**PLANNED UNIT DEVELOPMENT  
& SUBDIVISION STAFF REPORT****Date: May 5, 2005**

<b><u>DEVELOPMENT NAME</u></b>	Heron Lakes at Skyline
<b><u>SUBDIVISION NAME</u></b>	Heron Lakes Subdivision, Phase Two, Corrected Plat, Resubdivision of and Addition to Lot 123
<b><u>LOCATION</u></b>	Northeast terminus of Blue Heron Ridge
<b><u>CITY COUNCIL DISTRICT</u></b>	District 4
<b><u>PRESENT ZONING</u></b>	R-1, Single-Family Residential District
<b><u>AREA OF PROPERTY</u></b>	35,745 square feet
<b><u>CONTEMPLATED USE</u></b>	3-lot, residential subdivision in an R-1, Single-Family Residential District, with side-yard setbacks reduced to seven (7) feet, and building site coverage increased to 45%.
<b><u>TIME SCHEDULE FOR DEVELOPMENT</u></b>	Immediate
<b><u>ENGINEERING COMMENTS</u></b>	Must comply with all stormwater and flood control ordinances. Any work performed in the right of way will require a right of way permit.
<b><u>TRAFFIC ENGINEERING COMMENTS</u></b>	Driveway number, sizes, location and design to be approved by Traffic Engineering and conform to AASHTO standards.

# SITE PLAN

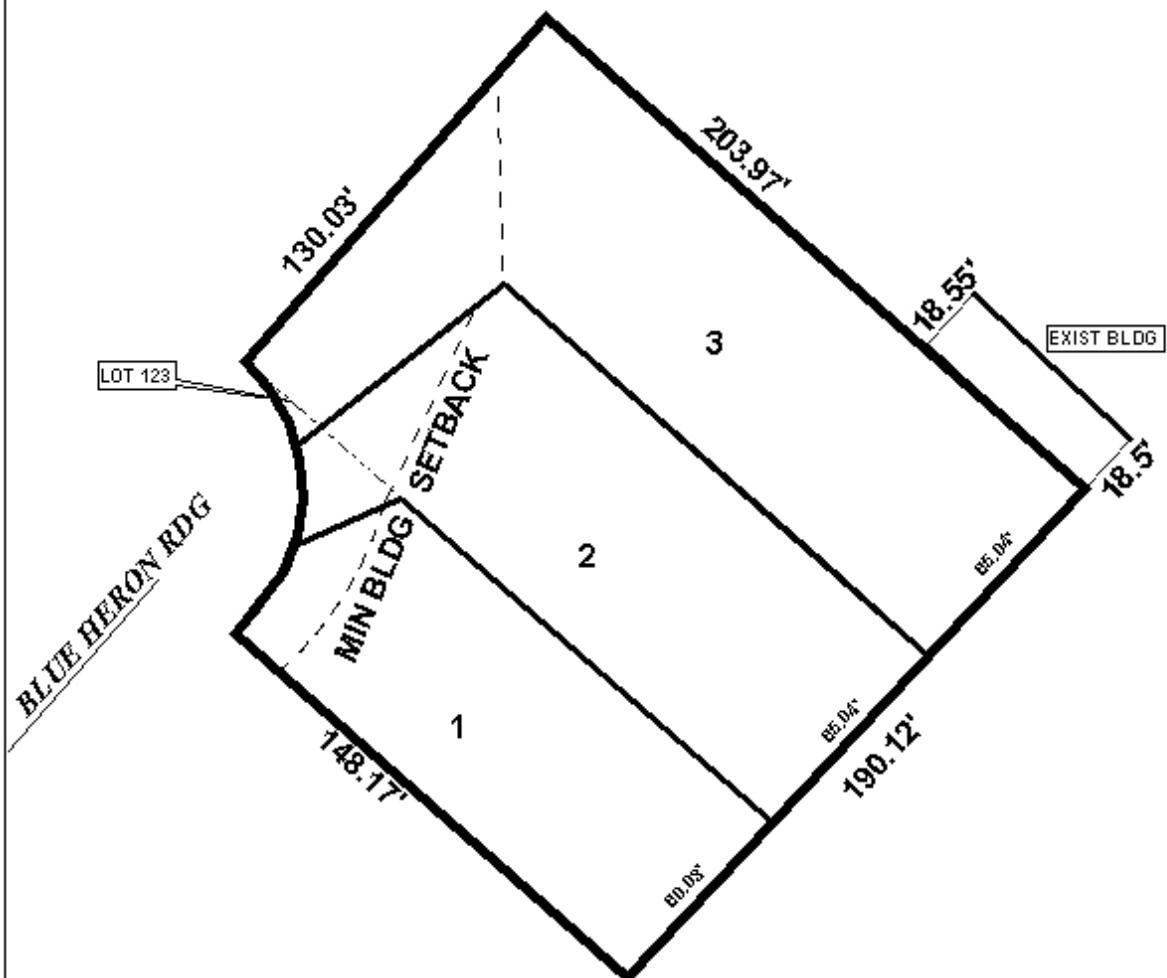
This application is for a lot that is part of a Planned Unit Development (PUD) that was approved on June 20, 2000, as well as for a portion of a parcel that includes golf and country club facilities. The original PUD, as amended, permitted minimum side yard setbacks of 7 feet for lots 65 feet wide or less, and it is also being requested for this application. This PUD and Subdivision application proposes a total of three lots, ranging in width from 60.03 feet to 65.04 feet. The original PUD, as amended, also permitted building site coverages up to 40%, an increase in site coverage above the standard 35% for R-1, Single-Family districts. The applicant has requested that the maximum building site coverage be increased to 45%, however, this would be 5% more than previously approved requests, and would be uncharacteristic for the Heron Lakes development. It is therefore recommended that the maximum building site coverage be limited to 40% for this application.

The proposed lot 3's depth to width ratio is approximately 4.7 (depth is 4.7 times the width of the lot at the minimum building setback line), which is greater than the 3.5 recommended in Section V.D.3. of the Subdivision Regulations. Lot 3's high depth to width ratio is due to the lot being flag-shaped in order to provide maximum frontage onto the existing golf course. Due to an existing building east of the proposed lot 3, options to reconfigure the lot are somewhat limited. Therefore, a waiver of Section V.D.3. could be considered appropriate.

**Planned Unit Development:** Based on the preceding, this application to amend the existing PUD is recommended for tentative approval, subject to the following conditions: 1) placement of a note on the final plat stating that the maximum building site coverage shall not exceed 40%; 2) graphic depiction of the approved setbacks on the plat as follows, and placement of a note on the final plat stating that the side yard setbacks shall be a minimum of 7 feet, that the front yard setbacks shall be a minimum of 25 feet, and that the rear yard setbacks shall be a minimum of 8 feet; 3) that the Engineer provide verification that the existing stormwater system, including designed and constructed detention, can accommodate the increased site coverage; and 4) full compliance with all municipal codes and ordinances.

**Subdivision:** With a waiver of Section V.D.3. of the Subdivision Regulations, the plat is recommended for tentative approval, subject to the following conditions: 1) placement of a note on the final plat stating that the maximum building site coverage shall not exceed 40%; 2) graphic depiction of the approved setbacks on the plat as follows, and placement of a note on the final plat stating that the side yard setbacks shall be a minimum of 7 feet, that the front yard setbacks shall be a minimum of 25 feet, and that the rear yard setbacks shall be a minimum of 8 feet; 3) that the Engineer provide verification that the existing stormwater system, including designed and constructed detention, can accommodate the increased site coverage; and 4) full compliance with all municipal codes and ordinances.
